## Planning Commission Meeting

**Rezone, Concept Plan  
Mountain View Estates II  
Thursday May 26, 2016  
Public Hearing**

**Author:** Gordon Miner, City Engineer  
**Subject:** Mountain View Estates II – Concept Plan  
**Date:** May 19, 2016  
**Type of Item:** Concept Plan Review

## **APPLICATION REVIEW CHECKLIST**

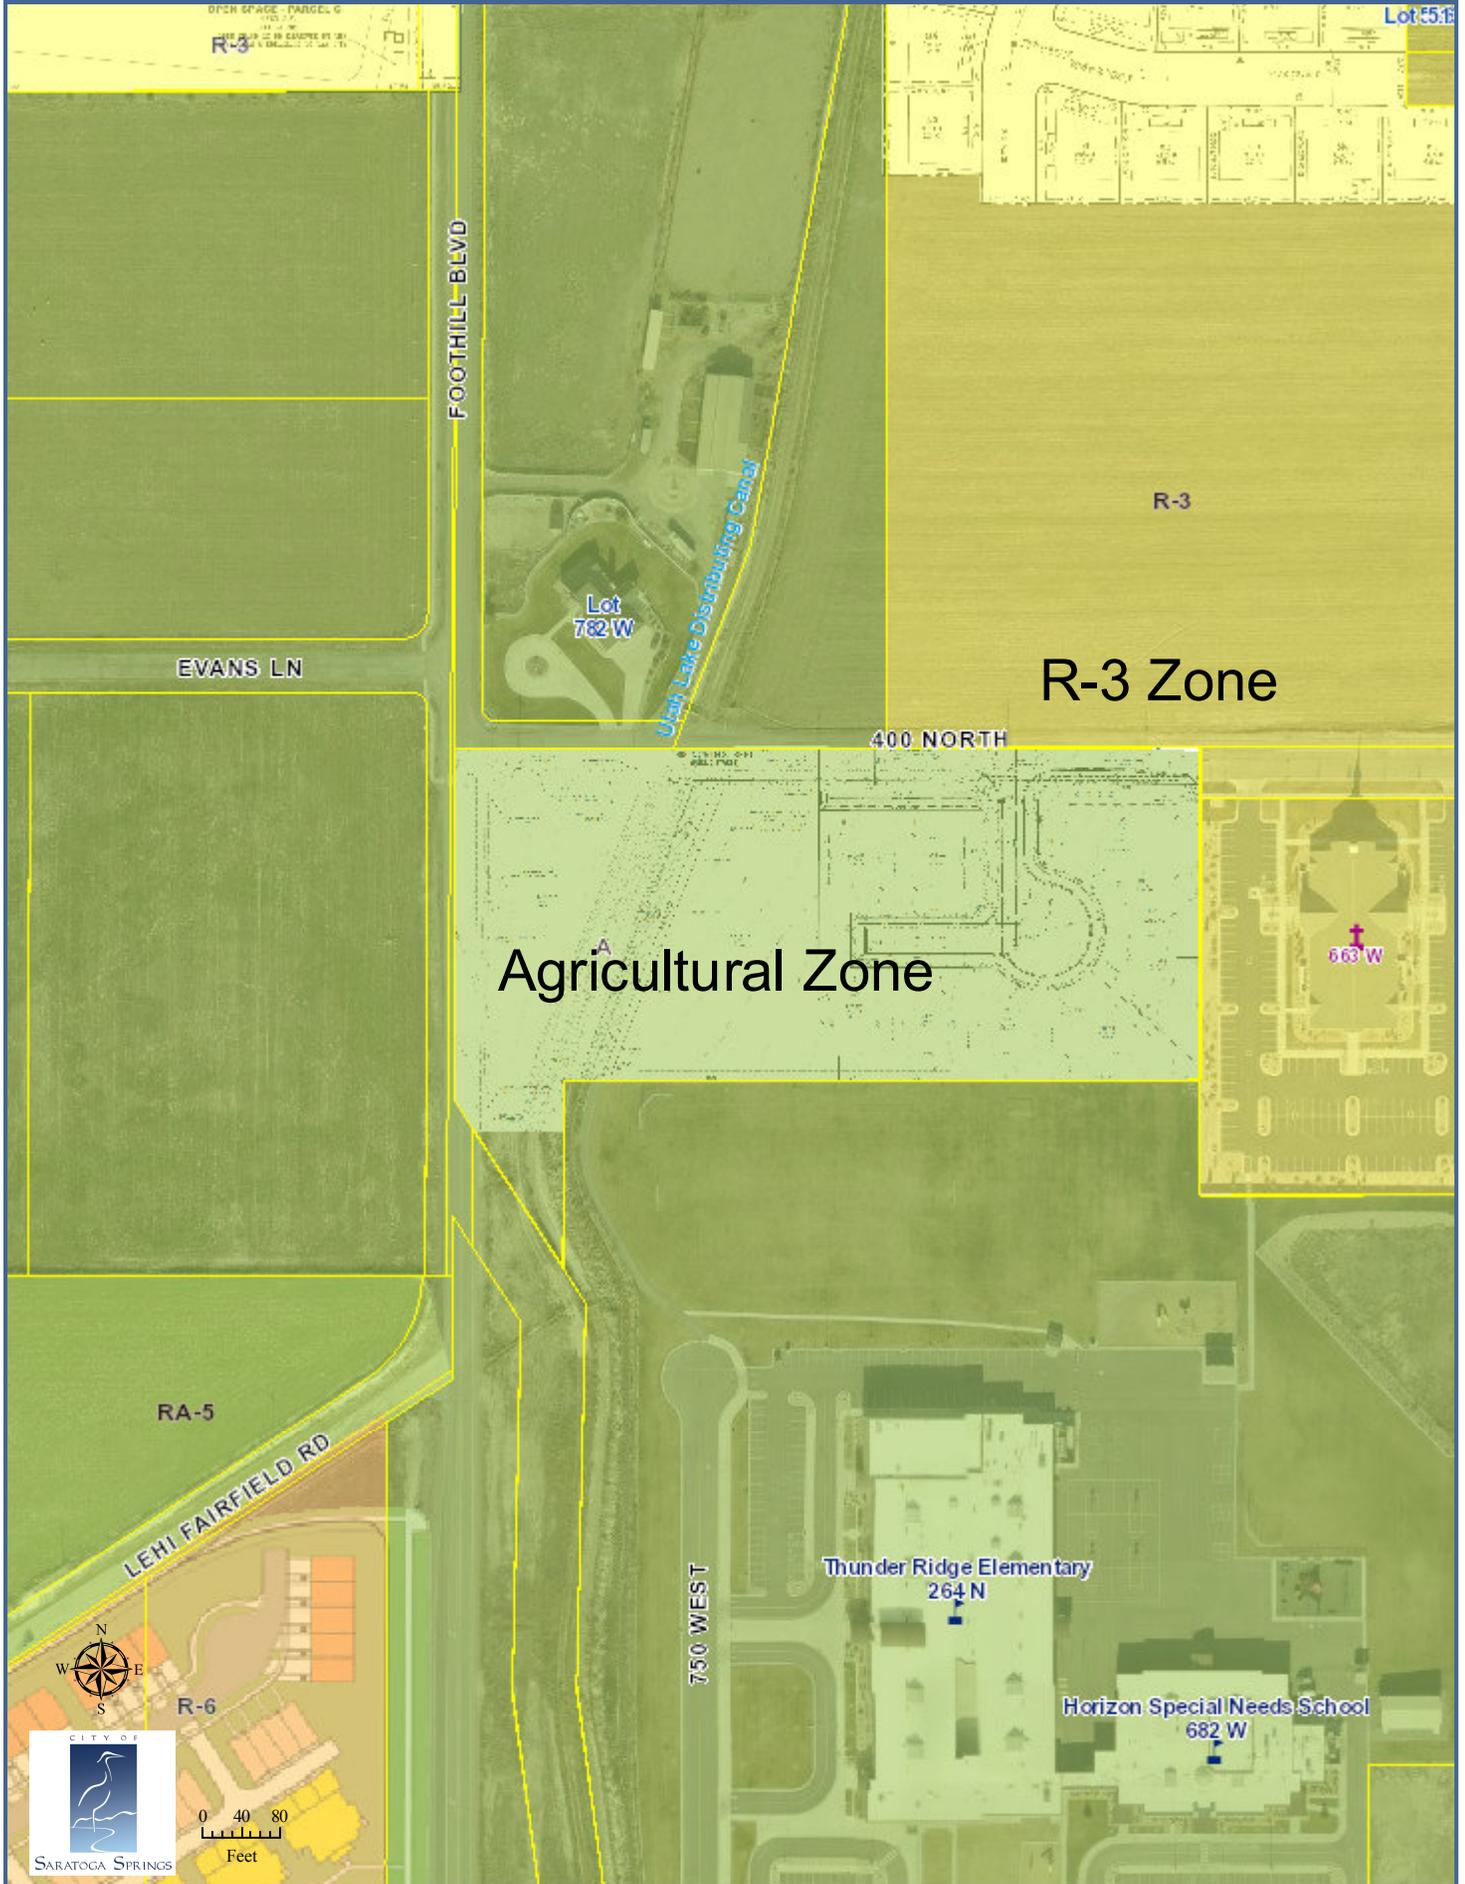
- A. Prepare construction drawings as outlined in the City's standards and specifications and receive approval from the City Engineer on those drawings prior to receiving Final approval from the City Council.
- B. Consider and accommodate existing utilities, drainage systems, detention systems, and water storage systems into the project design. Access to existing facilities shall be maintained throughout the project.
- C. Comply with the Land Development Codes regarding the disturbance of 30%+ slopes.
- D. Incorporate a grading and drainage design that protects homes from upland flows.
- E. Project must meet the City Ordinance for Storm Water release (0.2 cfs/acre for all developed property) and all UPDES and NPDES project construction requirements.

- F. Developer shall meet all applicable city ordinances and engineering conditions and requirements in the preparation of the Construction Drawings.
- G. Project bonding must be completed as approved by the City Engineer prior to recordation of plats.
- H. All review comments and redlines provided by the City Engineer are to be complied with and implemented into the construction drawings.
- I. All work to conform to the City of Saratoga Springs Standard Technical Specifications, most recent edition.
- J. Developer shall prepare and record easements to the City for all public utilities not located in a public right-of-way.
- K. Developer is required to ensure that there are no adverse effects to adjacent property owners and future homeowners due to the grading and construction practices employed during completion of this project.
- L. Concept review does not guarantee Lot yield.

**CONCEPT PLAN**

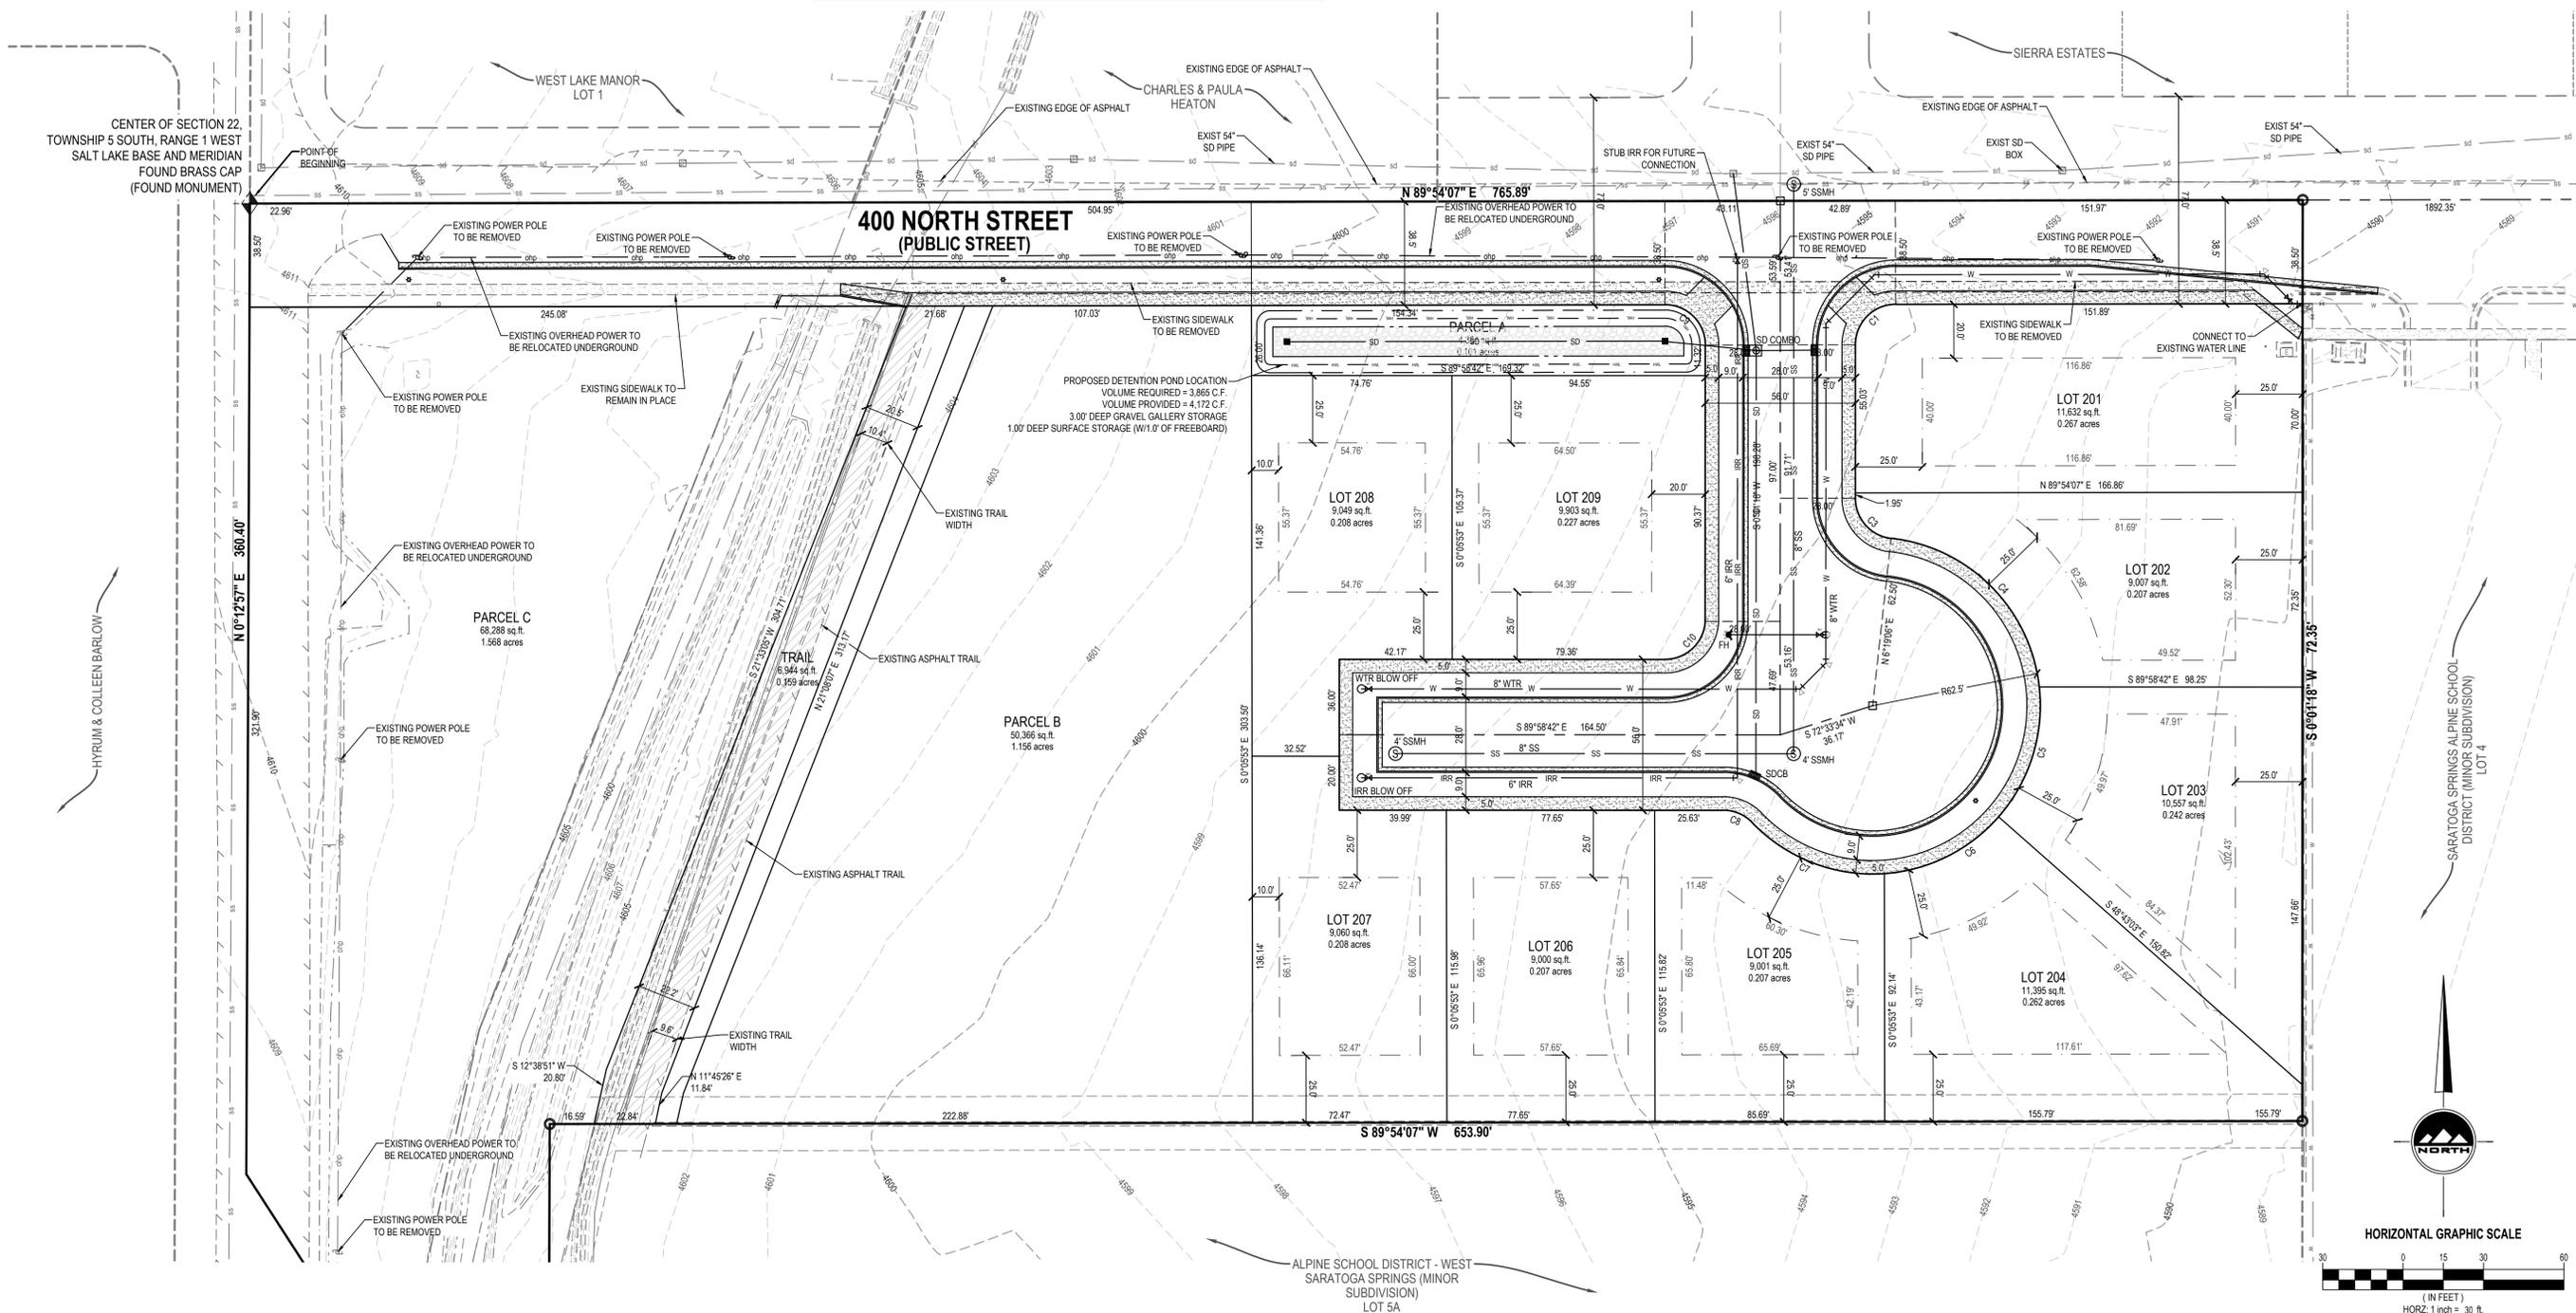
- DRC:
  - 3.14.16 – Comments: Discussion over the requirement of not leaving a remnant parcel and how to get the power lines buried.
  - Remove the chain link fencing on the west side of the trail and replace with wrought iron fencing, which will count toward the open space improvements. 15' for open space and then the City will purchase the rest.
- UDC: dates/comments

- Open Space – 15% minimum. **Can Comply.** The concept plan includes a Trail Parcel of 0.159 acres , a detention basin, and which accounts for 4.13% of open space. The applicant is suggesting payment in lieu of open space.

- Sensitive Lands – All sensitive lands shall be placed in protected open space and may not account for more than 50% of the required open space. **Can Comply.** There is a canal and easement that runs through the property. This needs to be identified as sensitive lands in open space calculations on the Preliminary Plat. The detention basin is also considered sensitive land.

- Maximum Block Length of 1,000 feet. A pedestrian walkway is required if over 800 feet. **Complies.** The longest street is 198.28 feet in length.

- A second access is required after 50 units. **Complies.** The plan only has 9 lots.
    - Lot design
      - Corner lots shall be 10% larger than the required minimum lot size. **Complies.** The two corner lots are 10% larger than the required lot size.

- No remnant parcels shall be created. – **Complies.** The concept plan does not leave any remnant parcels.
      - No double access lots, except for corner lots. **Complies.** There are no double access lots other than the 2 corner lots.
